PROJECT NAME: MARION OAKS TOWNHOMES

PROJECT NUMBER: 2024110024

APPLICATION: MAJOR SITE PLAN #32203

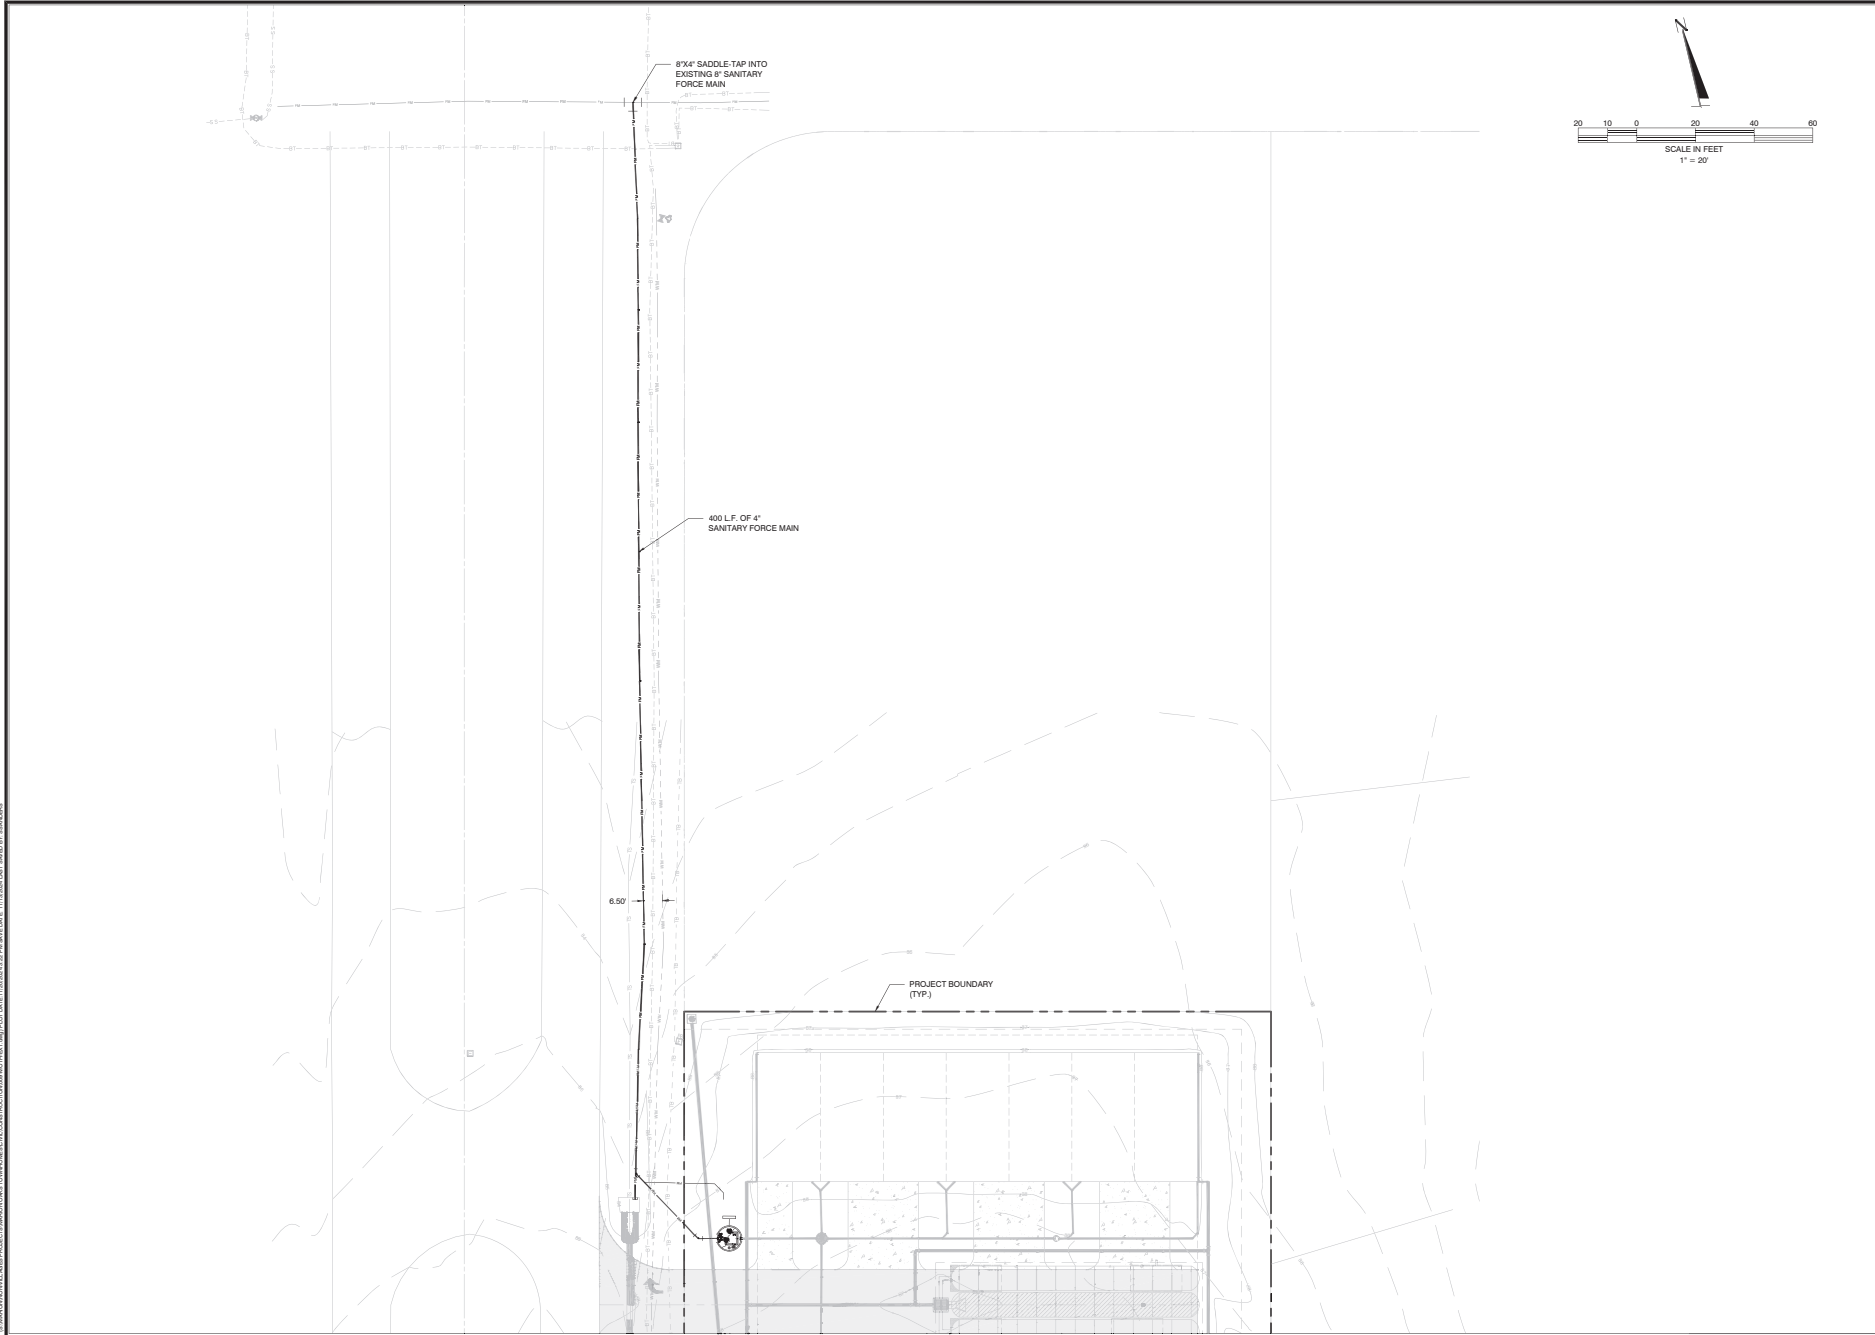
REMARKS: 4.22.25 PG08 - 8"x4" connections needs to be a tapping sleeve. Prev. (2) 1" Gate Valve needs to be 3/4" curb stop on both meter banks. (3) What material are you using for cross, reducer, tee, bend, etc.
Comment. Sheets 08, 09 - see changemarks

- 26 DEPARTMENT: UTIL - MARION COUNTY UTILITIES
REVIEW ITEM: 6.14.2.A - Sewer Connection Requirements
STATUS OF REVIEW: NO
REMARKS: 4.22.25 PG08 - ARV must be on top of the pipe or offset to the inside. Prev. Comment. Sheets 08, 09 - see changemarks
